AXIS P3245-V/-LV  
indoor mounting bracket

AXIS P3224-V/-LV MkII and AXIS P3225-V/-LV MkII  
indoor mounting bracket

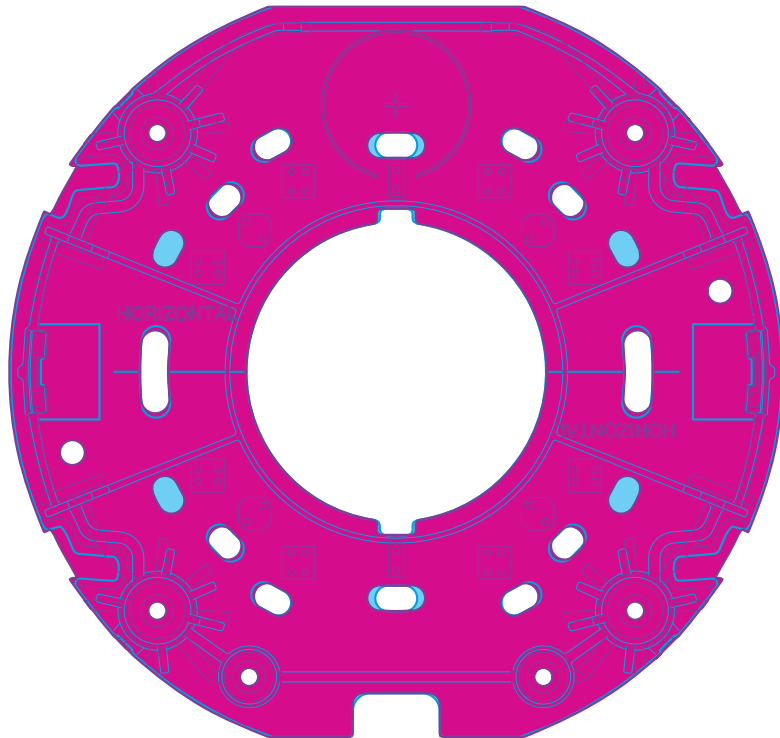
- > To support both horizontally and vertically mounted double gang boxes as well as more Axis accessories, four new holes were added.
- > To improve IK rating from IK08 to IK10, two holes were removed and 12 holes were made slightly smaller.
- > Together with the AXIS Conduit Adapters, all new AXIS P32 and AXIS M32 cameras support both 1/2" (M20) and 3/4" (M25) conduits.
- > The brackets of all new AXIS P32 (indoor and outdoor) and AXIS M32 cameras now have the same footprint.
